Technical Service Bulletin

NUMBER: 24-25-99

Cold Air Leaking Into Passenger Compartment Foot Well.

1999 - 2000 (WJ) Grand Cherokee

FIGURE 1

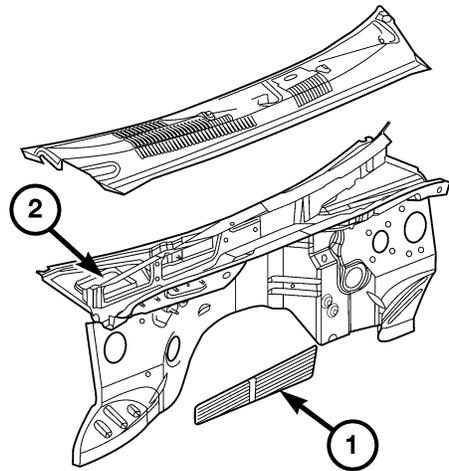
1. Remove the windshield wipers and cowl cover.
2. Remove the heater A/C air inlet screen.
3. Reach into the opening and feel the foam seal around the entire perimeter of the opening. The seal should be present around the entire perimeter of the cowl opening. If the seal is mis-positioned, insert the seal back into position. In some situations where small pieces of the seal are broken off or missing, it may be necessary to use adhesive backed foam tape, p/n 04318028, to seal this location. If large pieces of the seal are missing, it will be necessary to remove the heater A/C housing and replace the seal. Refer to the service manual for these procedures. The seal part number is 050112709AA.

- 4. Install the air inlet cover.
- 5. Install the cowl cover.
- 6. Install the windshield wipers.
